bb-ldo — Design Document

bb-ldo - board review (P8, adversarial, fresh context)

Board: kicad/bb-ldo.kicad_pcb, 50.000 x 26.420 mm, 2 layers, 5 parts. Mode block-basics / scope block-only / binding canonical - protection, filtering, indicators, test points, config and mechanical are SCOPE, and their absence is not reported below. The board size is compared only to what the design earned and recorded, never to any stated number.

reports/renders/bb-ldo_top.png

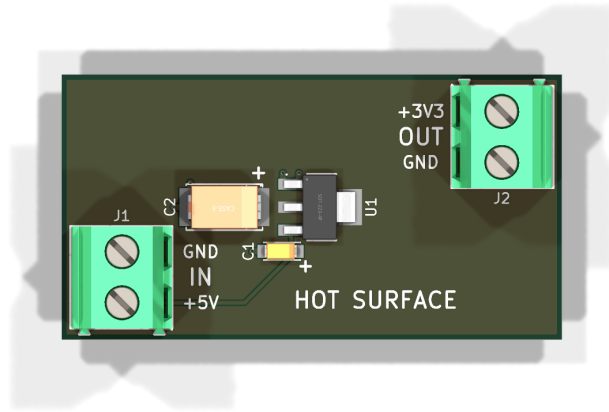
Connector orientation - the top-down render lies about this. In `bb-ldo_top.png` both terminals appear to have their wire openings facing the board interior, which would be a serious defect. They do not. Three independent artifacts agree that both wire entries face **outward**: (a) the WRL mesh has two 4.0 x 5.5 mm rectangular openings centred exactly on the pin x-positions on the footprint -y face and nothing comparable on +y; (b) the footprint's two silk arrows sit on that same -y face pointing inward, the standard wire-insertion marking; (c) `bb-ldo_left.png`, rendered for this review, shows J1's cage openings squarely facing the camera at -X while J2 presents its back. J1's entry face is 0.86 mm inside the left board edge, J2's 0.86 mm inside the right. **Correct.** What the top view shows on the inboard faces is a shallow moulded recess, not a hole.

Capacitor polarity, after assembly. C2's added + at (24.800, 29.400) is directly over pad 1 at x=24.788 - the anode, on +3V3 - 0.52 mm clear of the body silk and outside the courtyard, so it is visible with the part fitted (`bb-ldo_top.png`, and the zoomed body in the centre crop shows the model's own light anode stripe on that same right-hand end, agreeing with the mark). C2's native marks are indeed useless: the band at local x=+2.20 is under the 7.3 x 4.3 body and the pin-1 dot is a 0.03 mm radius circle. C1 needs no added mark - its footprint's own + glyph lands at (29.500, 38.810), outside its courtyard on the anode side, and its model stripe agrees. ****Both correct and both legible.****

reports/renders/bb-ldo_bottom.png

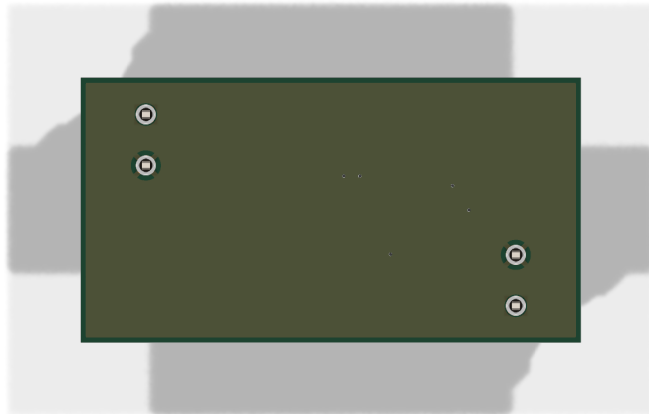
- J1.2 (GND) and J2.2 (GND) are both `thru_hole` pads with (`layers "*.Cu" "*.Mask"`), i.e. their barrels penetrate F.Cu and B.Cu directly. Confirmed visually in `bb-ldo.bottom.png`: both show a four-spoke thermal relief into the plane, while J1.1 (+5V) and J2.1 (+3V3) show an isolating antipad.

Hand-solder access. J1 and J2 are the only hand-soldered parts and they solder from the bottom, where B.Cu carries nothing but the GND plane and three tented vias - no SMT parts, no obstructions (`bb-ldo_bottom.png`). C1 and C2 are on the opposite face, 8.3 mm and further from the nearest THT pin; ****an iron at J1 or J2 cannot reach them.**** The only hand-solder problem on this board is F3.
